Addendum #1

Project Name: Cattle National Bank & Trust - Fallbrook
6550 Merchant Drive
Project No.: 12054
Issued: May 01, 2013
Bid Date: 2:00 pm, CDT May 14, 2013

Revision to Detail: G9/A300

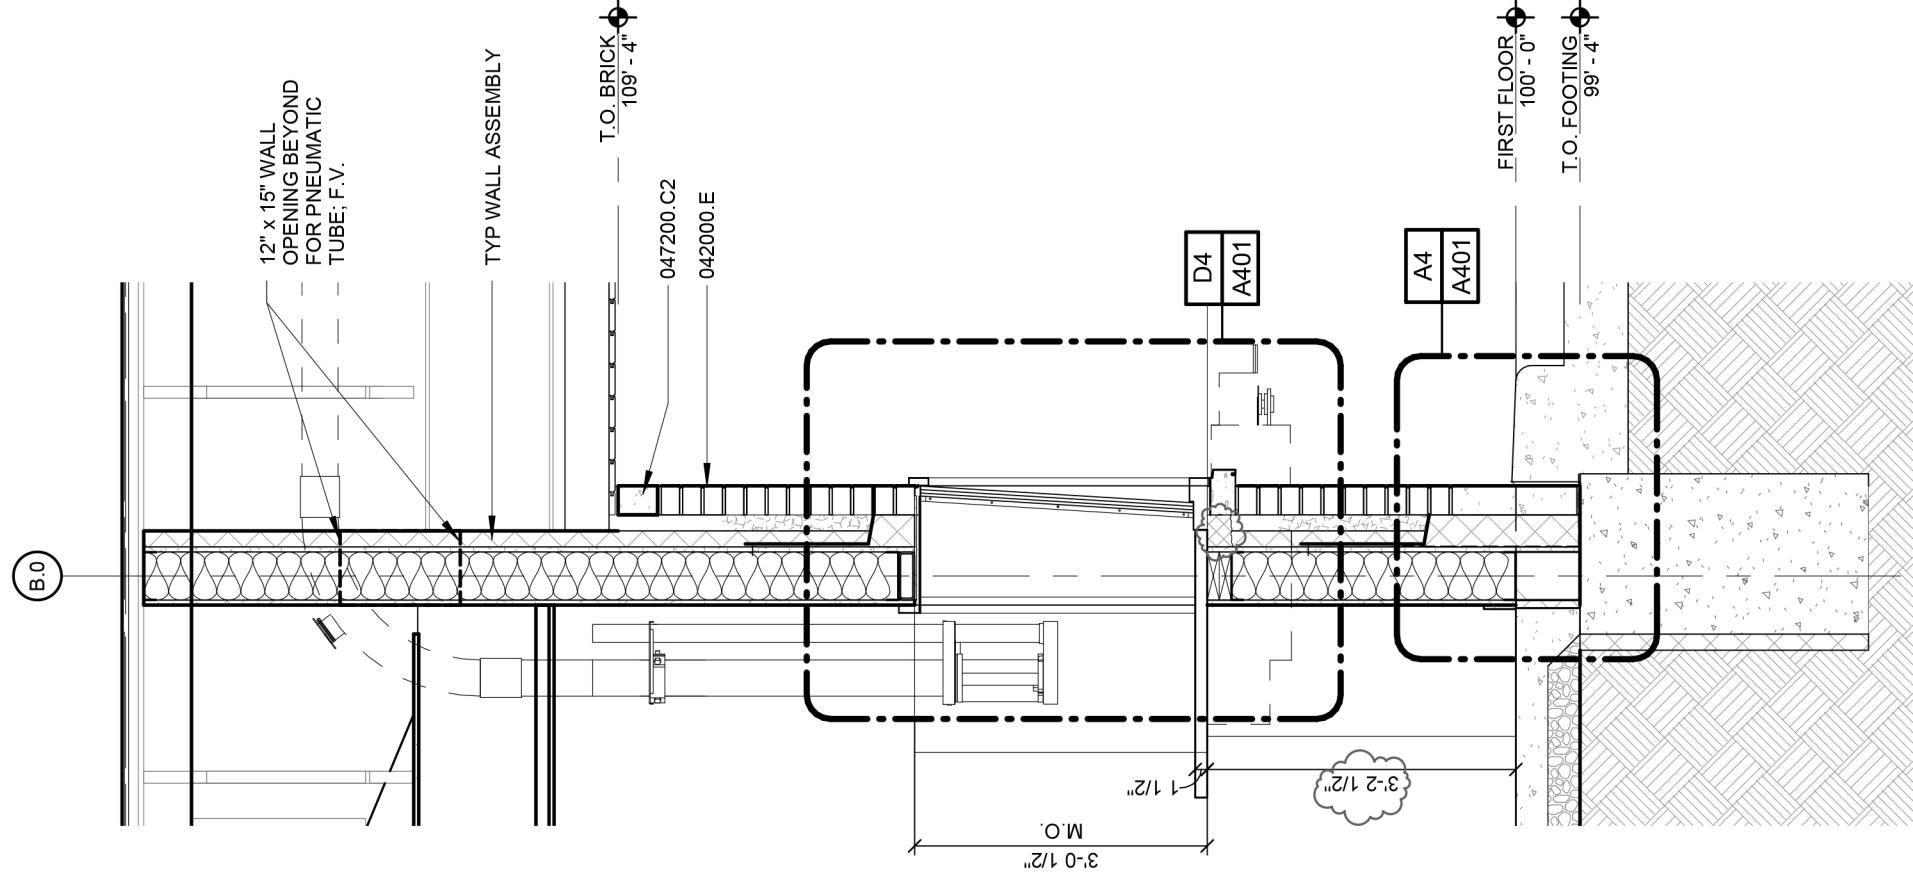
- a. A4/A300: Moved up Thru-wall Flashing Assembly, 2-Piece Counterflashing, and Termination Bar one brick coursing to coordinate with A10/A402 and Structural. Refer to Attachment A08.
- b. G9/A300: Graphically coordinated window location in section with details. Refer to Attachment A09.
- c. G4/A300: Graphically updated 3" spray foam insulation to coordinate with D4/A401 and changed dimension from finish floor to bottom of counter to be 3'-2 ½". Refer to Attachment A10.

Revision to Detail: A3/A301 & KEYNOTES

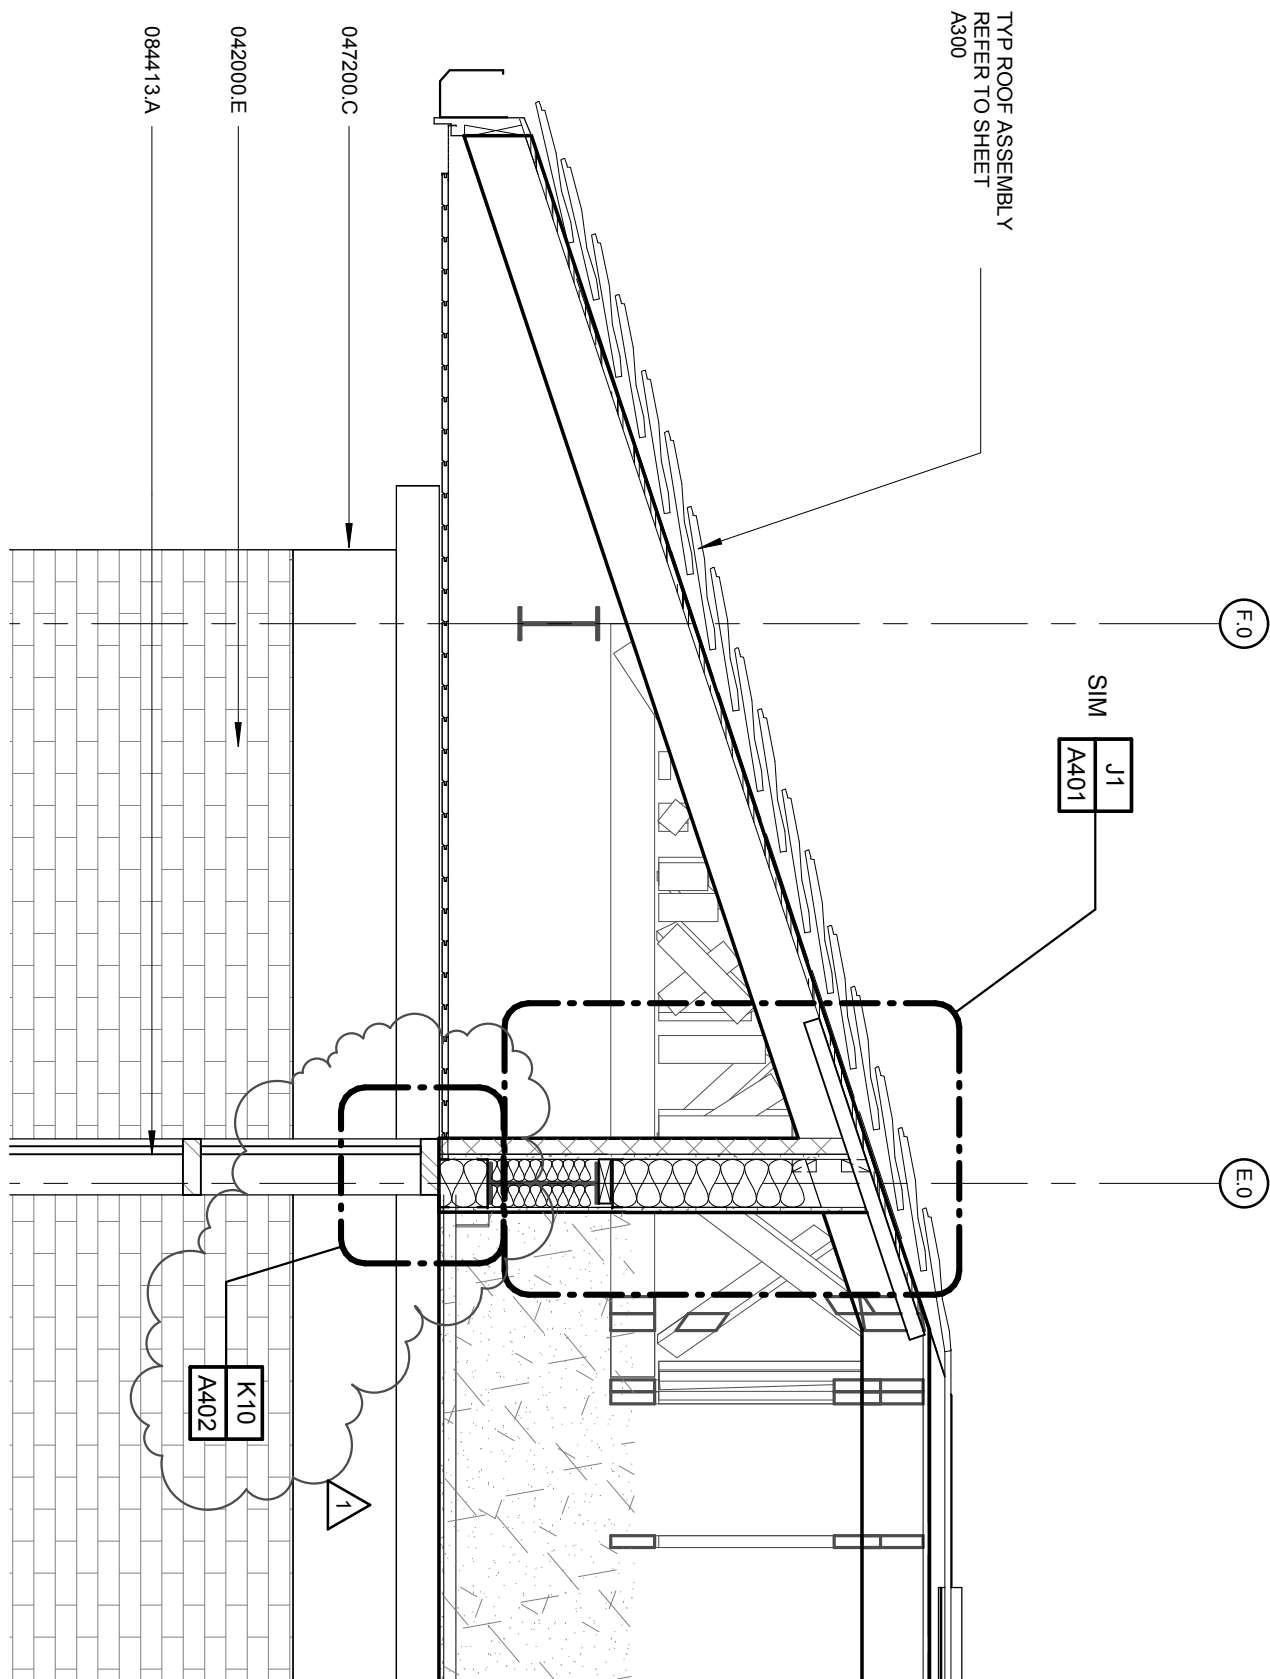
- a. A3/A301: Added dimension of 3.12 degrees to clarify angle at which to taper the stone on the northwest face of the Chimney. Added inside dimensions at the top and bottom of the Chimney. Modified wall type to include rigid insulation and added Keynote 072100.A3 "2 ½" Extruded Polystyrene Insulation". Changed Keynote 076200.D to 076200.D2 "2-Piece Step Counterflashing". Refer to Attachment A11.

Revision to Detail **A1/A302**

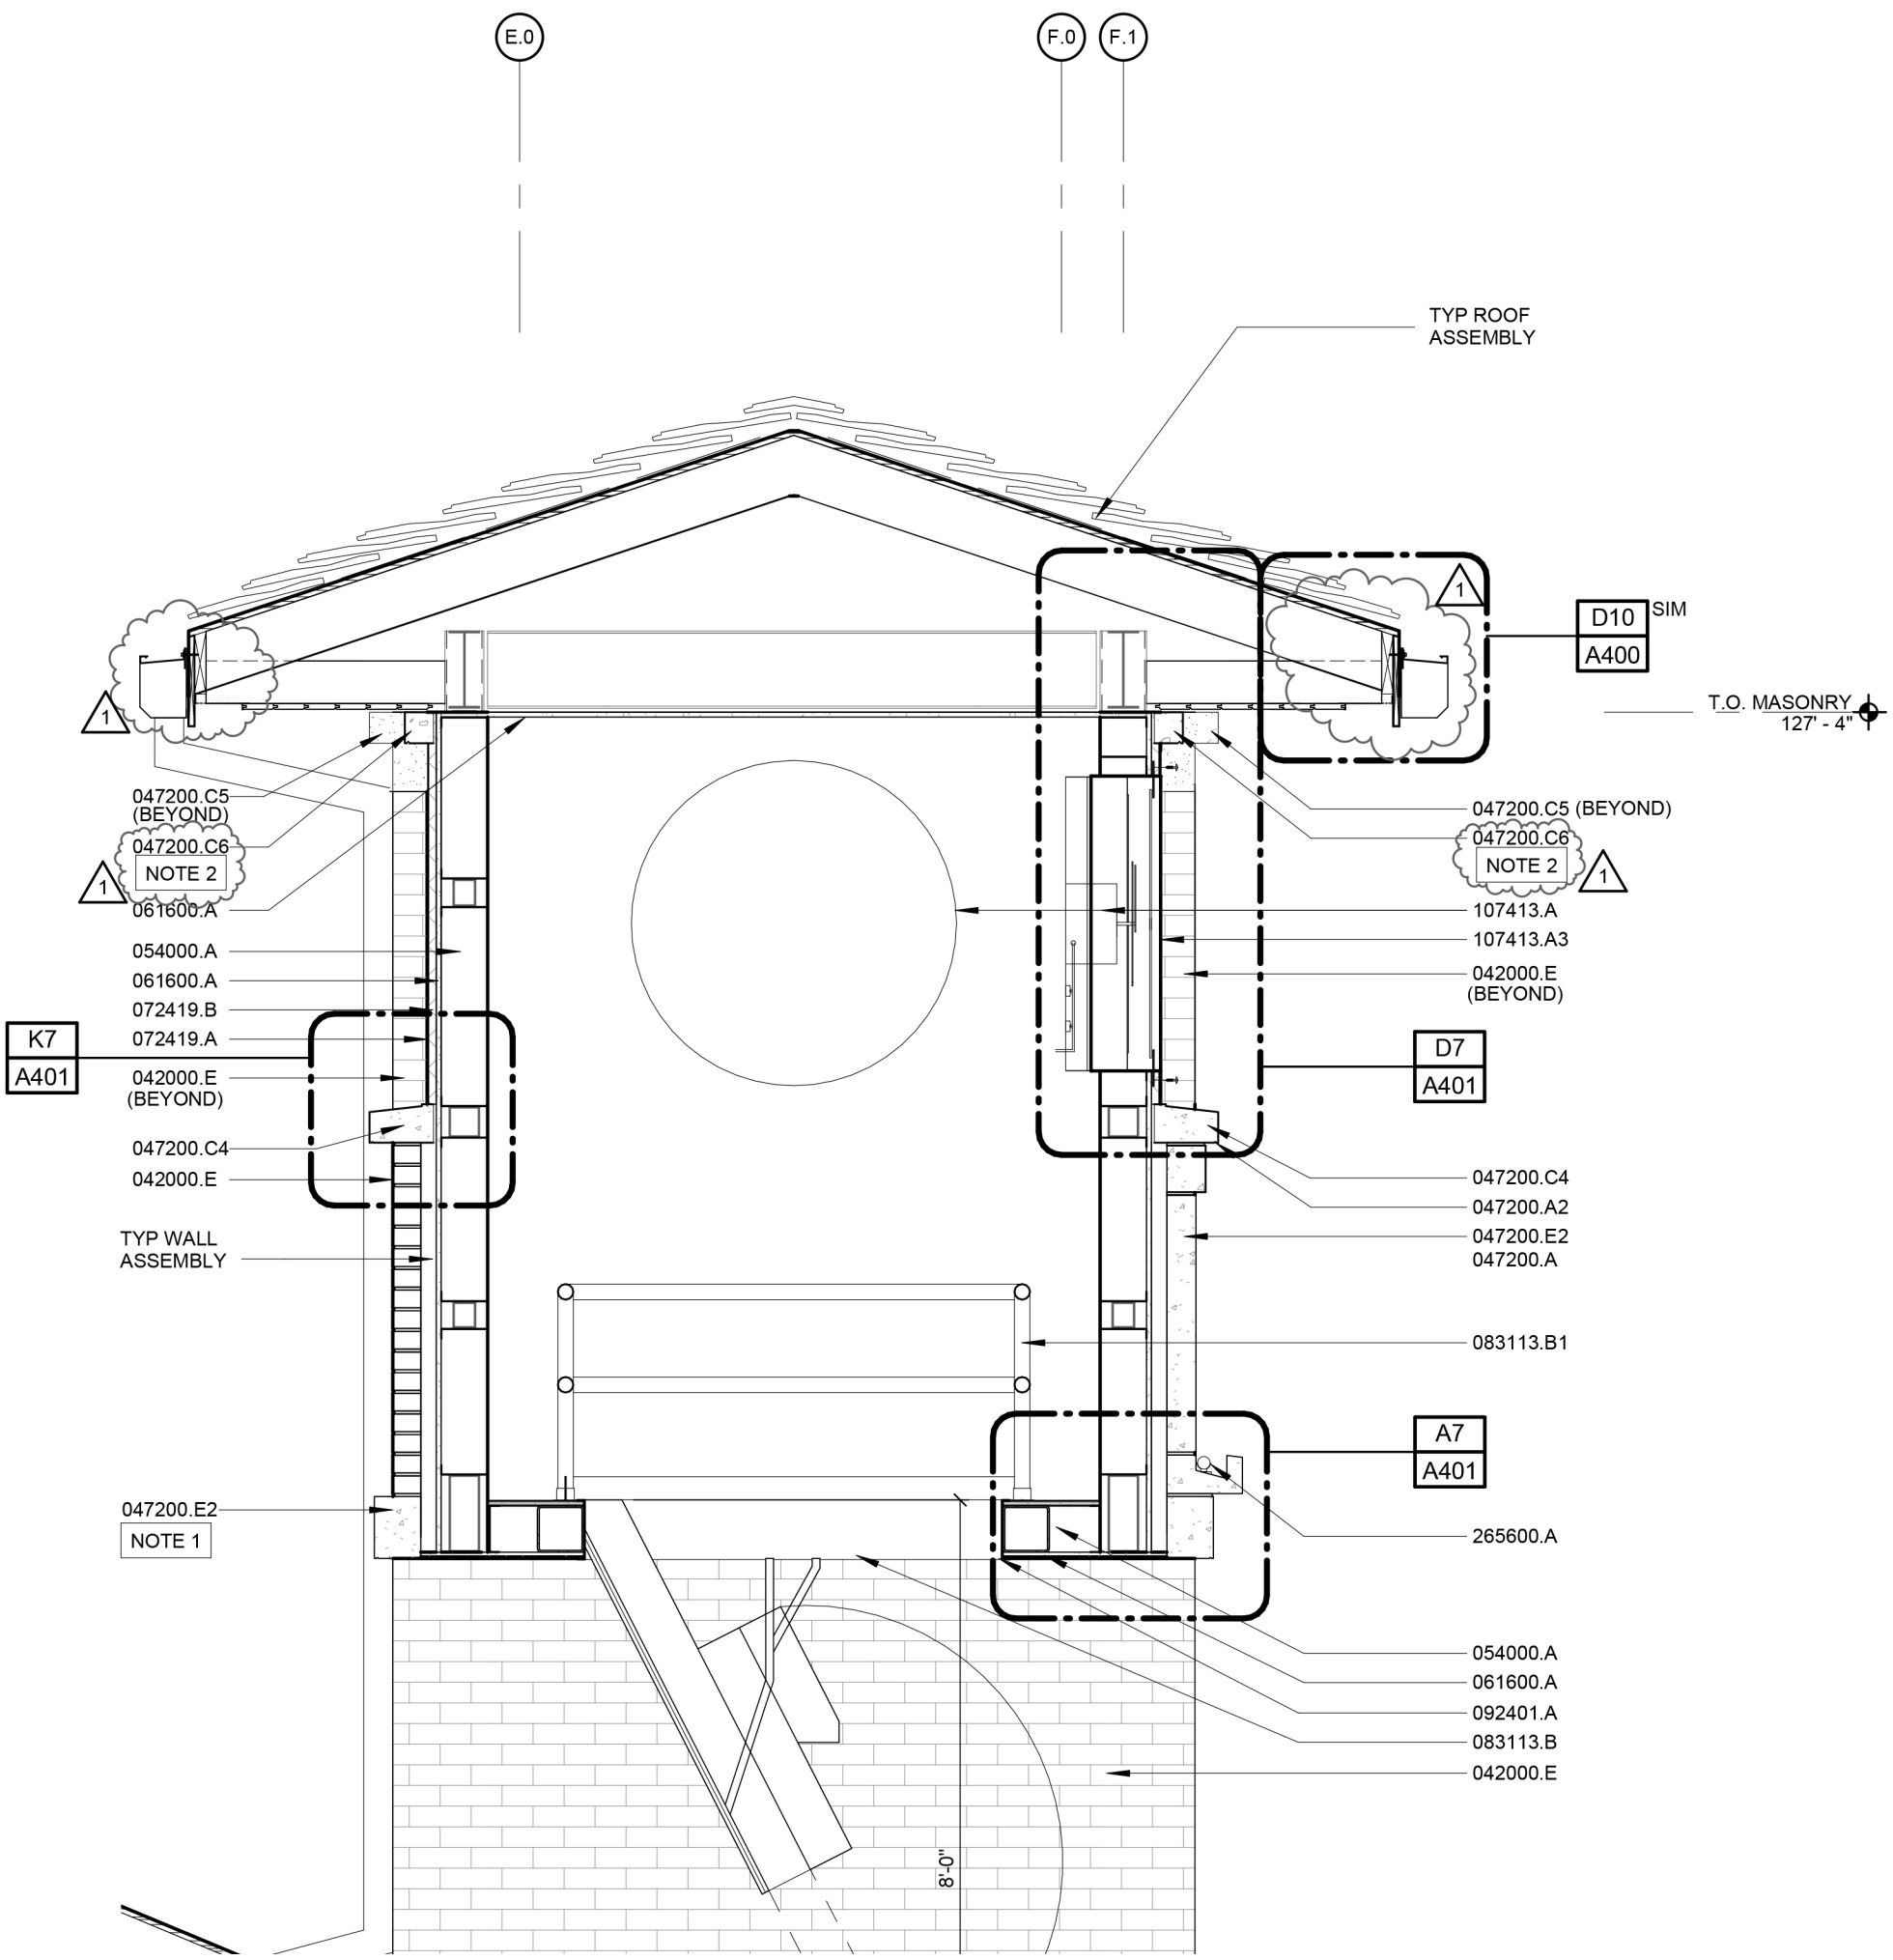
- a. A1/A302: Added detail callout K10/A402. Refer to Attachment A12.
- b. A8/A302: Raised roof 2 1/16" and raised the gutter 3 1/16" to coordinate with the typical roof edge detail (D10/A400). Added Sheet Specific Note 2 at Cast Stone Belt Course – Style 6 (047200.C6). Sheet Specific Note 2 reads "Precast to be self-supporting. Connect to the cast stone on either side or notch the abutting precast (047200.C5) to allow precast to bear". Refer to Attachment A13.

Revision to Detail **A1/A400**

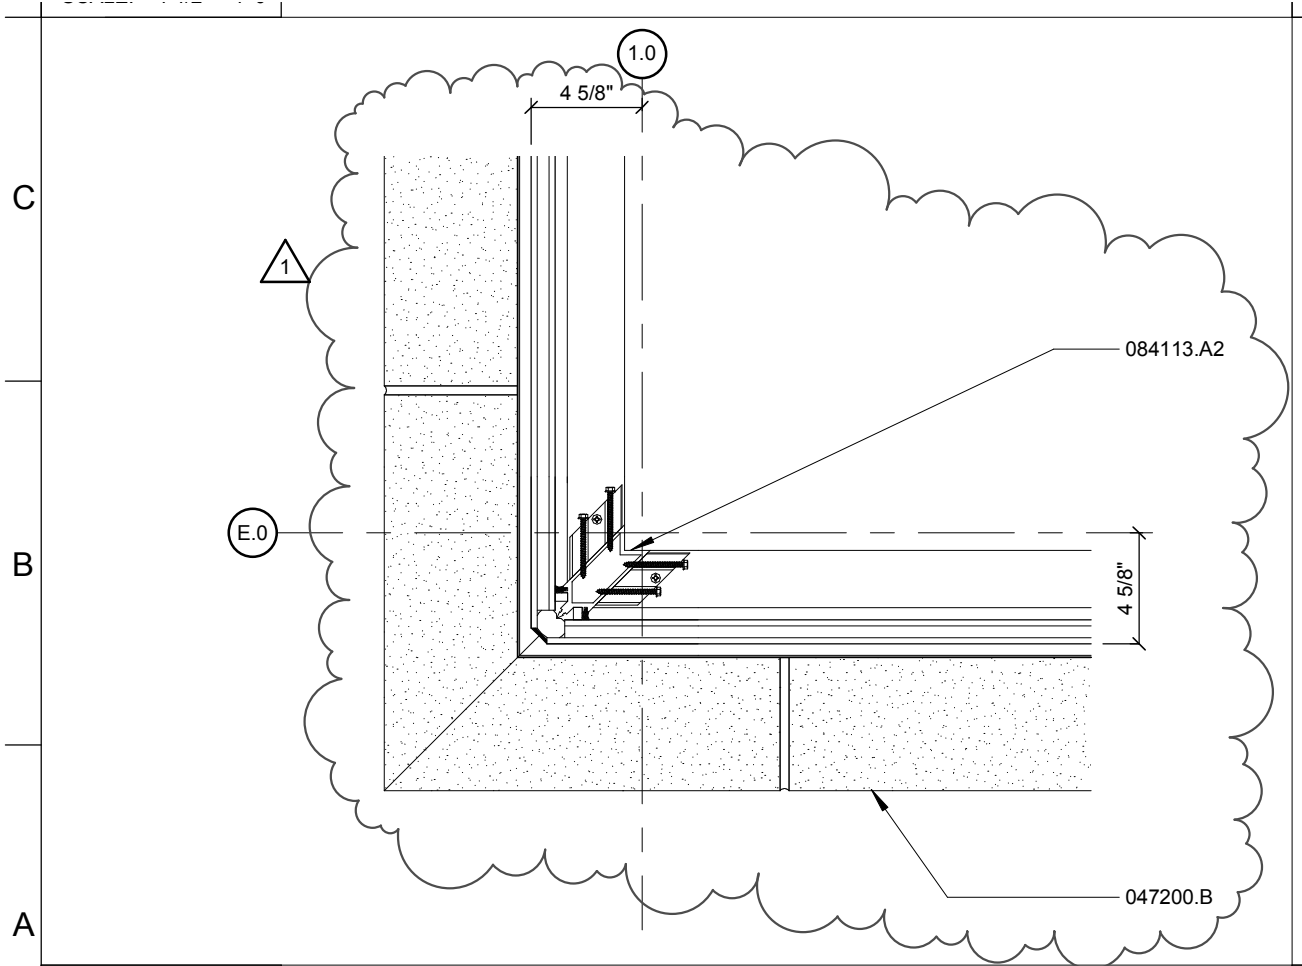
- a. A1/A400: Coordinated windows location from column line E with other details. Added keynote 084113.A2. Revised dimensions. Added joints at precast sill. Refer to Attachment A14.
- b. D10/A400: Eliminated dimension and added keynote. Refer to Attachment A15.

Revision to Detail J1/A401

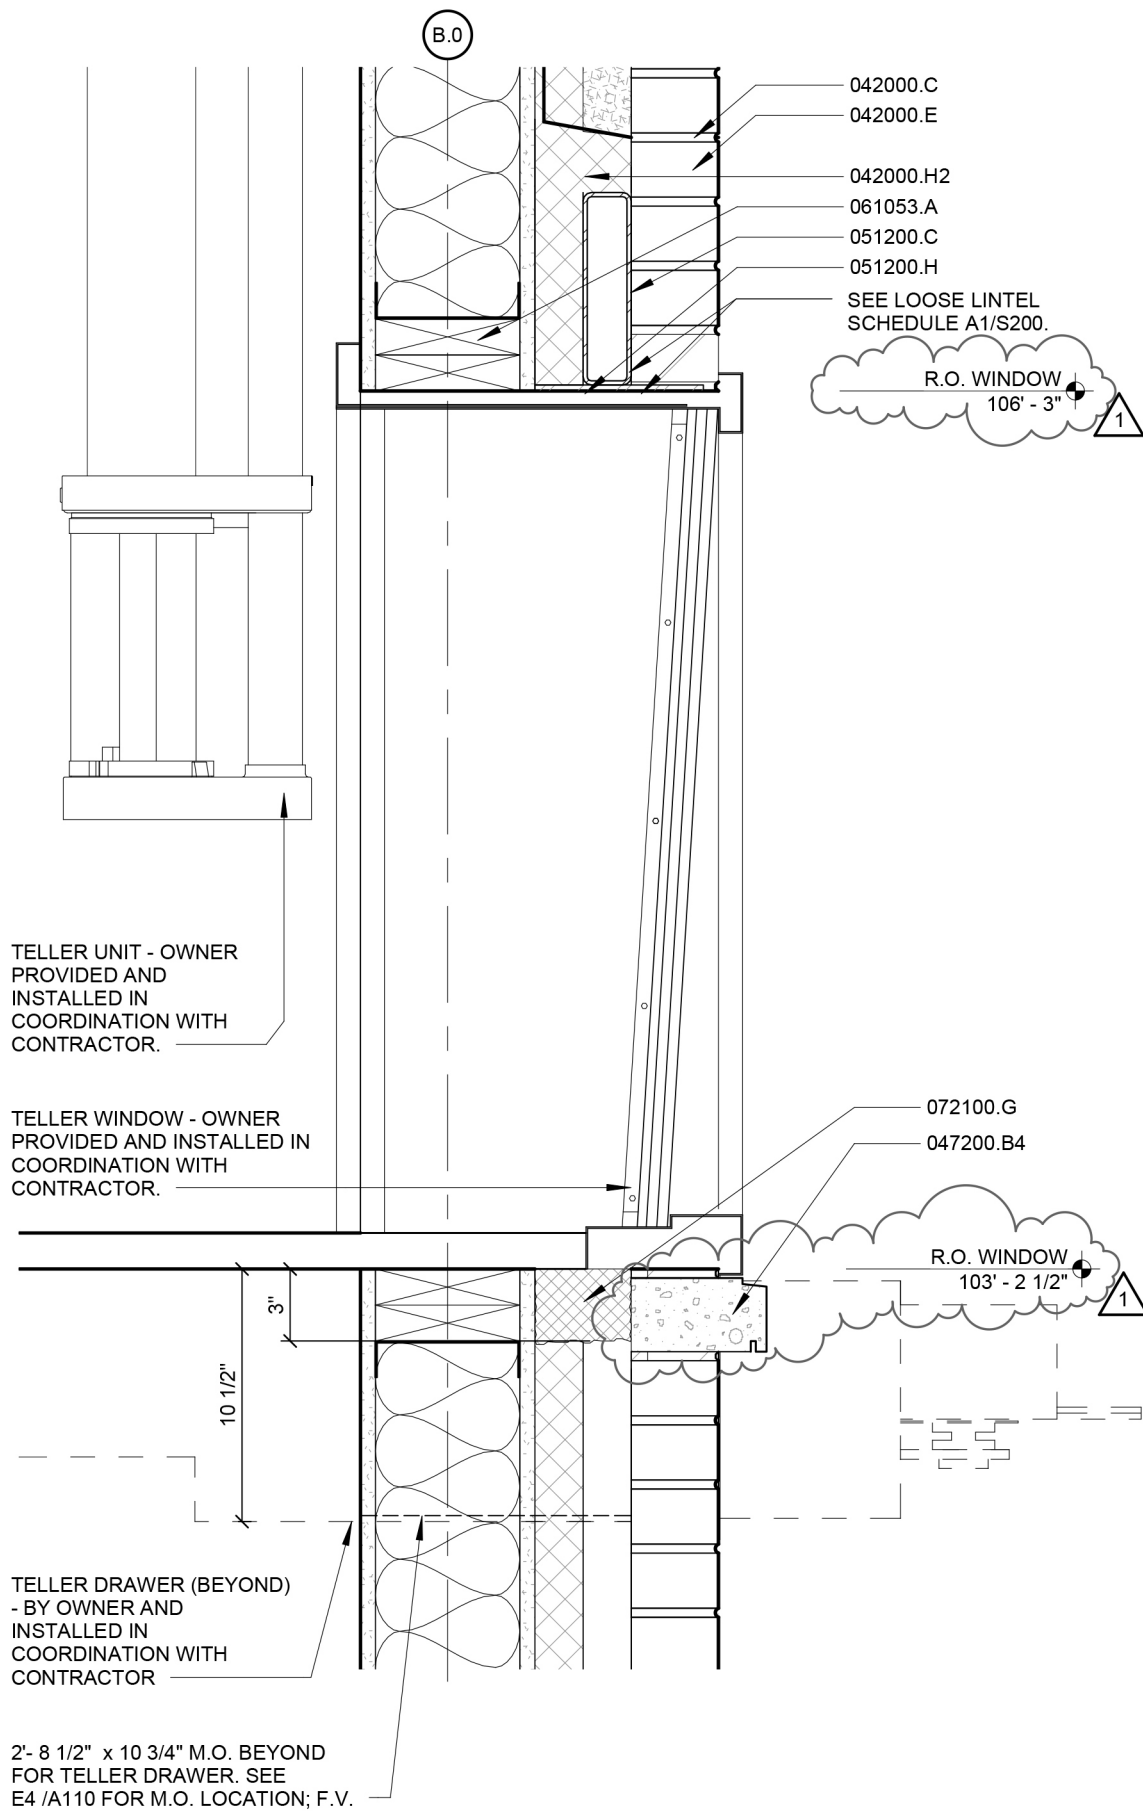
- a. J1/A401: Updated pre-cast at jamb and added note. Refer to Attachment A16.
- b. D4/A401: Updated pre-cast at sill to coordinate with the rough opening elevation of the Teller Window. Revised R.O. Window elevations to be 103'-2 ½" at the bottom of the Teller Window and 106'-3" at the top of the Teller Window. Refer to Attachment A17.
